**“AMENDMENT” OF THE
PRELIMINARY DRAINAGE REPORT
FOR
CLAREMONT COMMERCIAL
SUBDIVISION FILING NO. 2
A RESUBDIVISION OF TRACT C OF
CLAREMONT BUSINESS PARK FILING NO. 2
EL PASO COUNTY, COLORADO**

FEBRUARY 2020

Project #44-037
PCD – SP 19-197

DESIGNED BY: GW SCALE: DATE: 02-11-2020
DRAWN BY: CLP HORIZ: 1"=60'
CHECKED BY: VAS VERT: N/A SHEET 1 OF 1 PDM01

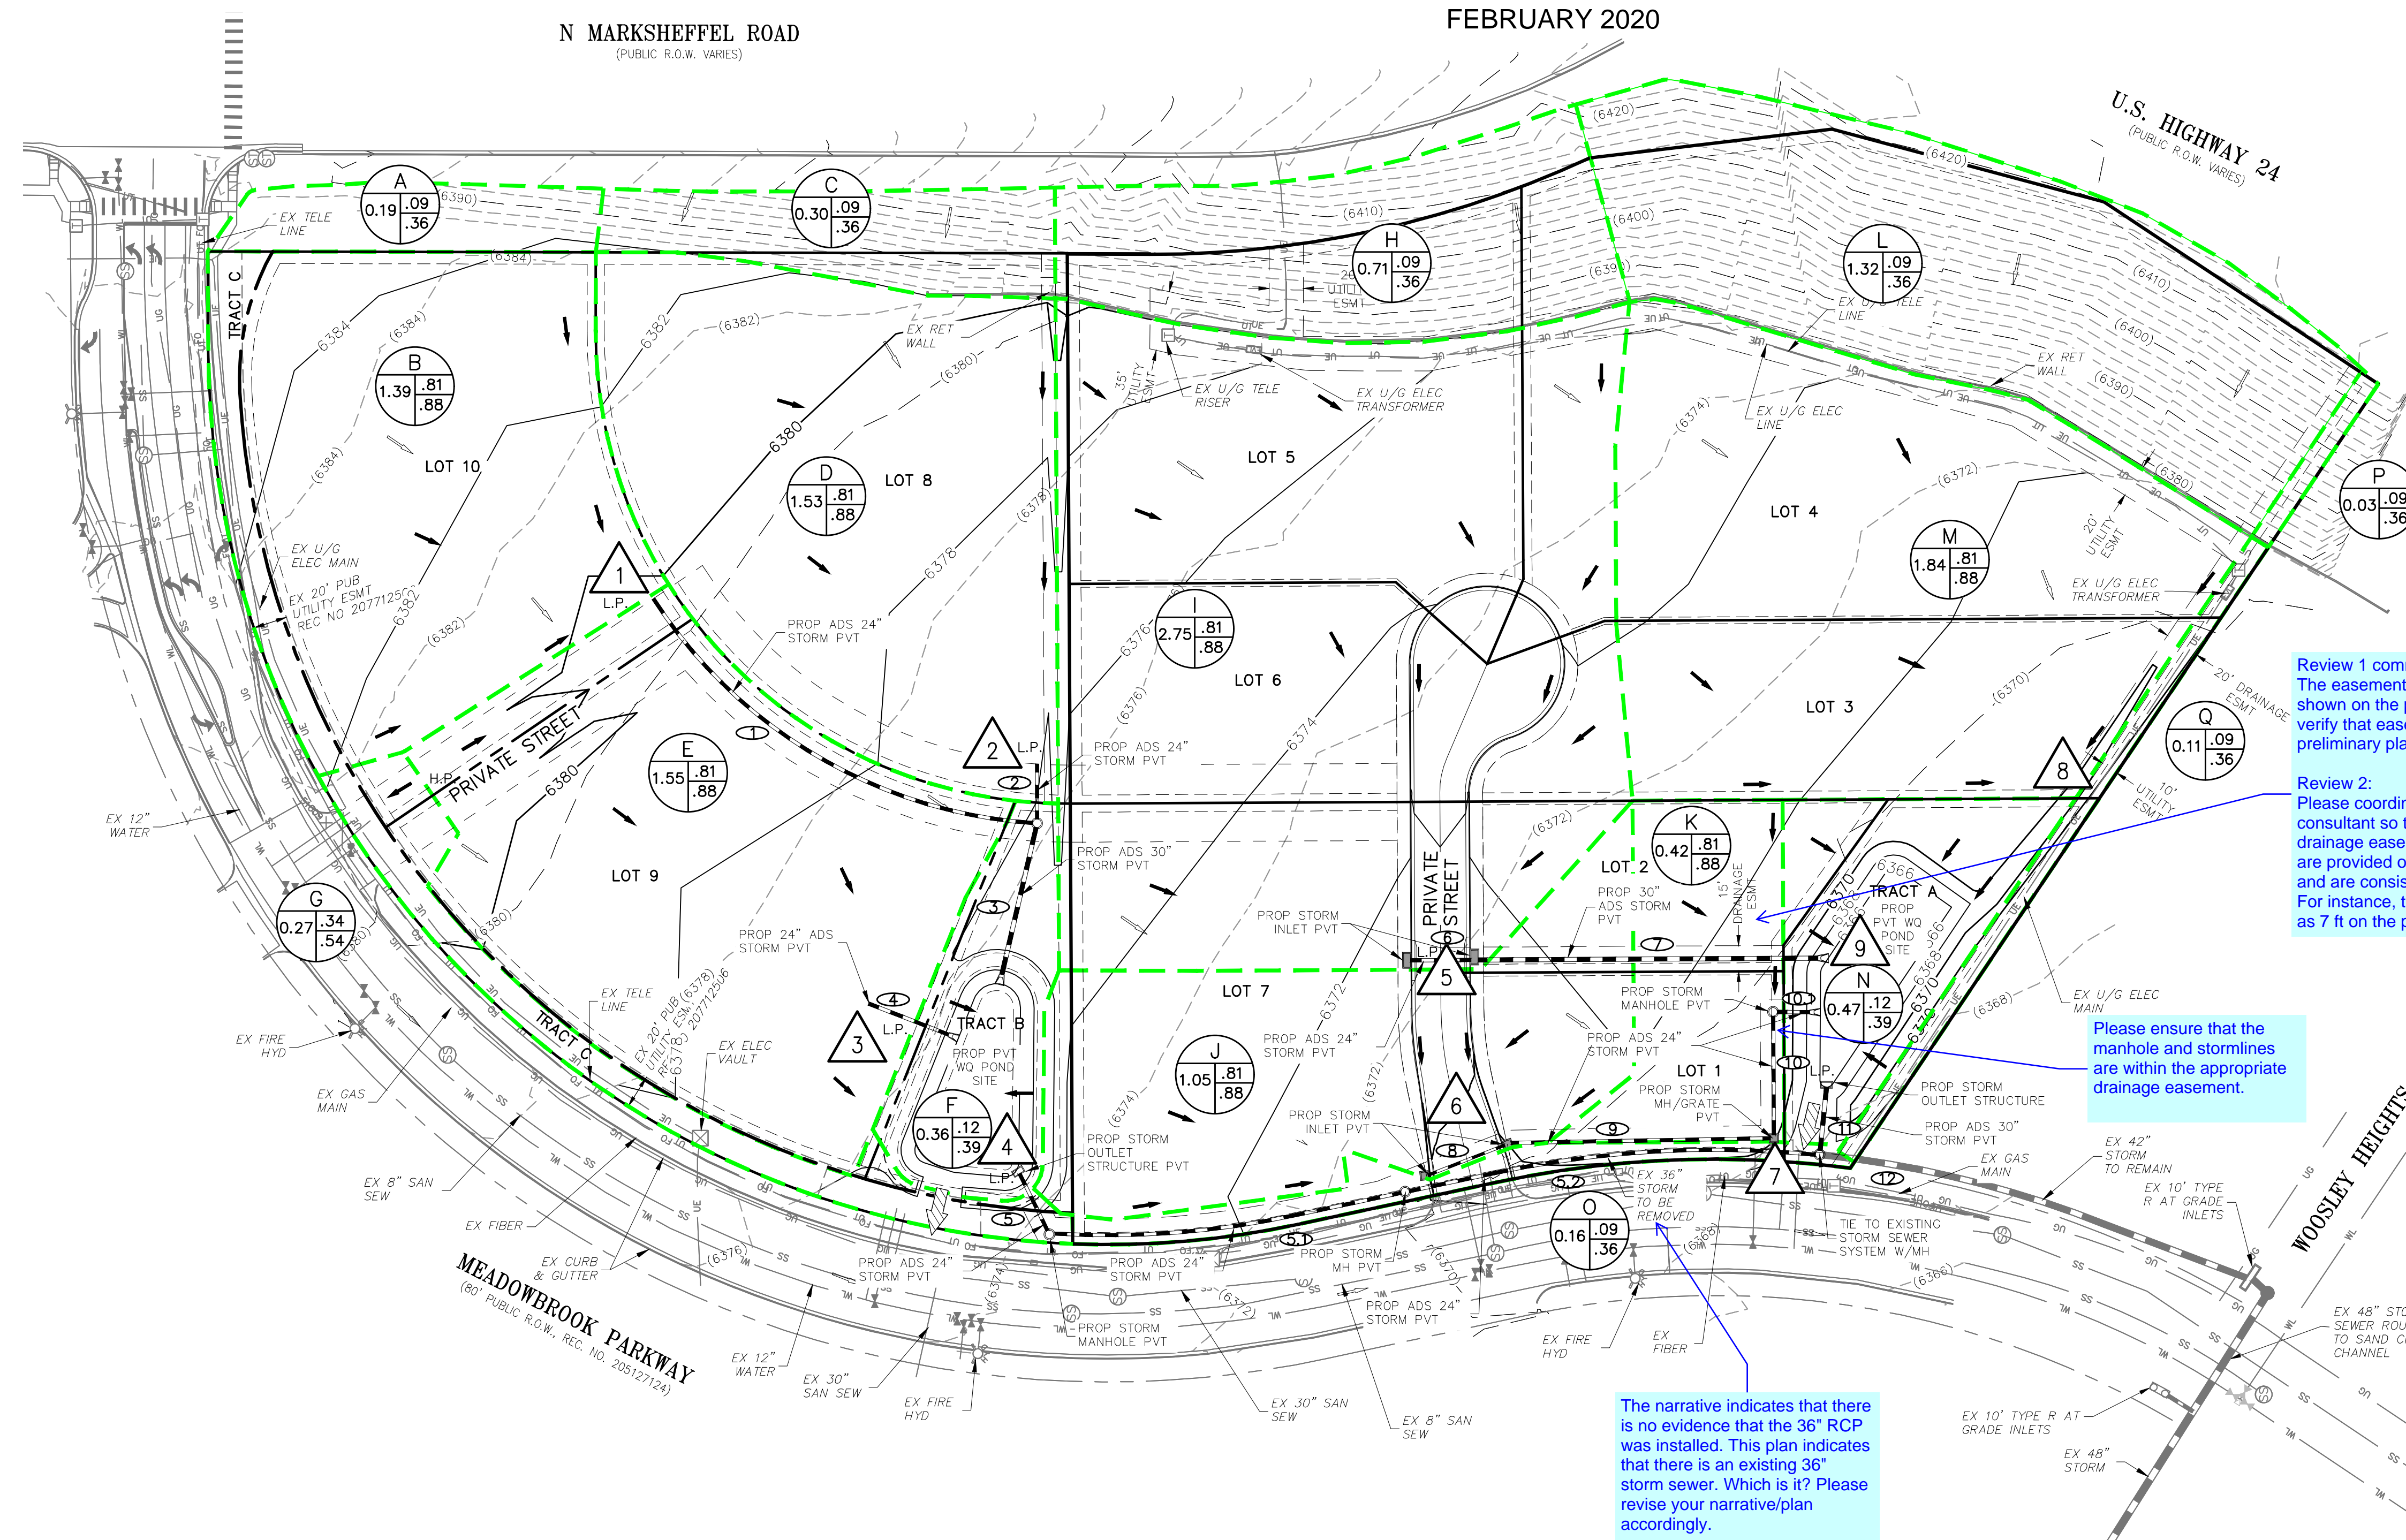
Review 1 comment:
The easement does not match what is shown on the preliminary plan. Please verify that easements shown match the preliminary plan. Revise accordingly.

Review 2:
Please coordinate with the planning consultant so that the necessary drainage easements for the storm lines are provided on the preliminary plan and are consistent between the plans. For instance, this easement is indicated as 7 ft on the preliminary plan

The narrative indicates that there is no evidence that the 36" RCP was installed. This plan indicates that there is an existing 36" storm sewer. Which is it? Please revise your narrative/plan accordingly.
